APPLICATION NO.	FILING DATE	FIRST NAMED INVENTOR	ATTORNEY DOCKET NO.	CONFIRMATION NO.
10/765,825	01/26/2004	James A. Mann JR.	DSCK-1246-C1	9085

Office Action Summary

DETAILED ACTION

enclosure (1)

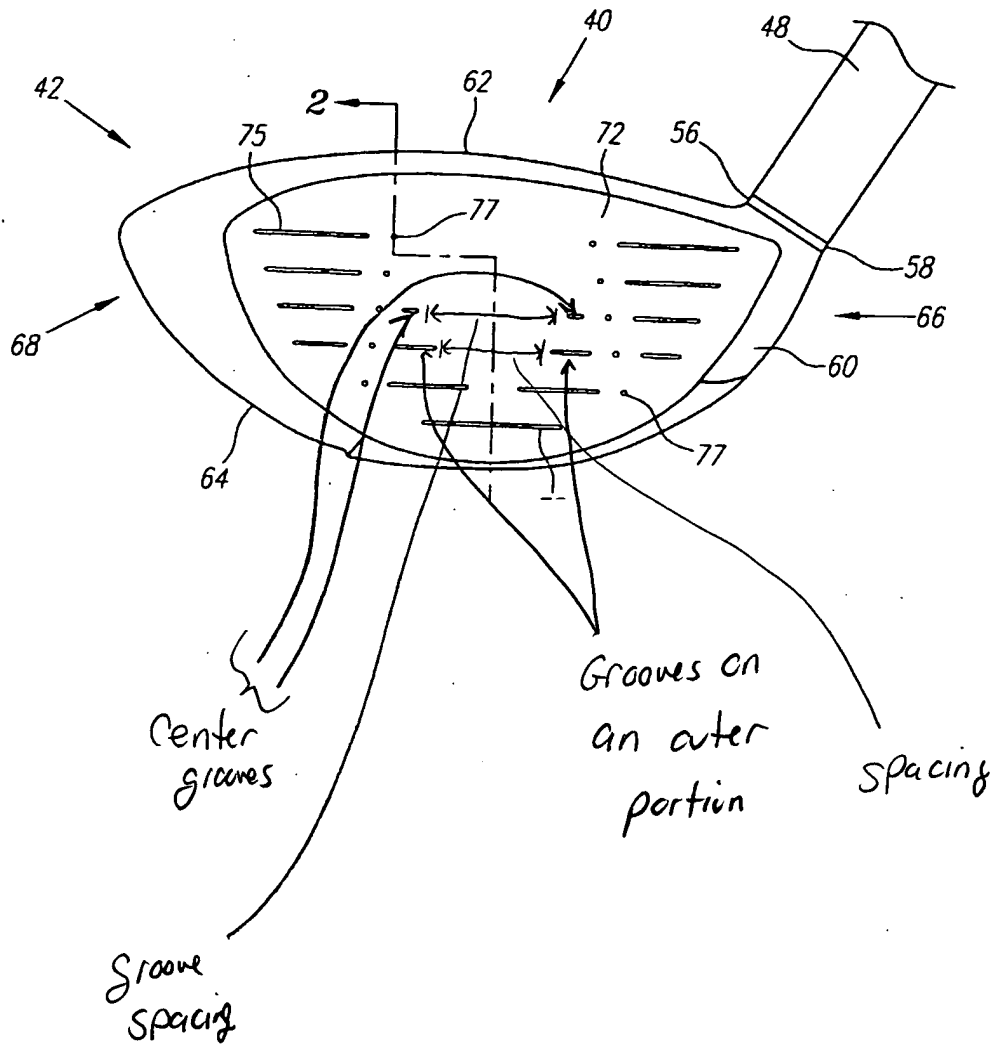
Galloway discloses a plurality of center grooves having a groove spacing of about 5 to 50 % greater than grooves placed on an outer portion of a face (See enclosure (1)) and a compared wood being a 1 club configuration in the form of a driver (Col. 4, Lns. 40-55).
